### Remote Cycle Unit

Owners of Wall Framing Machines fitted with Stanley Bostitch nail guns (including N50, N55, N60, N70, N80, N86, N100 series nailers) fitted with the Model N80K2 Remote Control Kit manufactured by Stanley Bostitch are advised to read this document carefully. It contains important information concerning the control of a hazard associated with any nail gun fitted with this remote cycle unit.

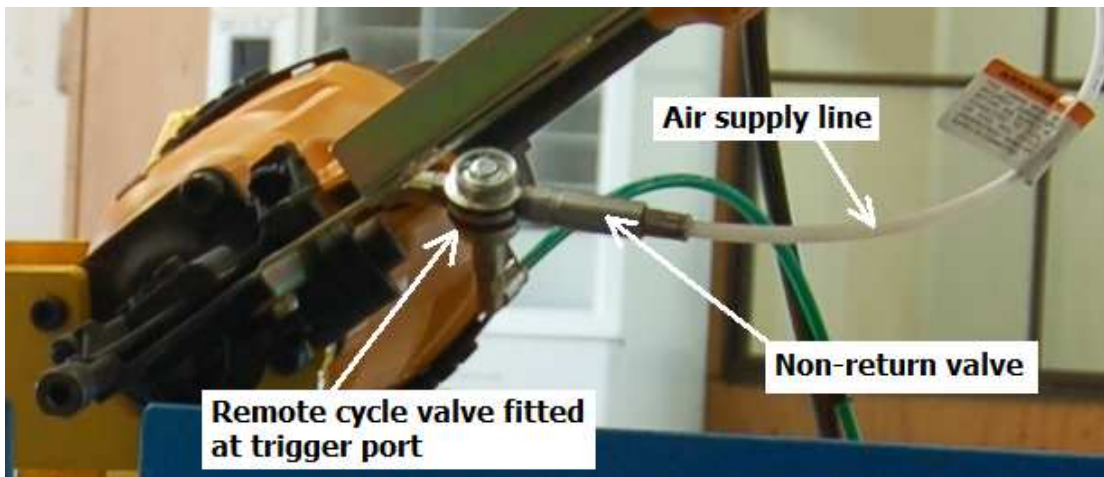
Loss of air pressure due to sudden disconnection, leaks or damage to the air supply line to the remote cycle valve can cause the nail gun to fire unexpectedly.

- Ensure that the remote cycle valve is mounted directly to the trigger port of the nailgun and fit a non-return valve to the supply port of the remote cycle valve. In the event of unexpected air loss at the air supply line the air pressure will be maintained in the valve, thus preventing unexpected firing of the nail gun.
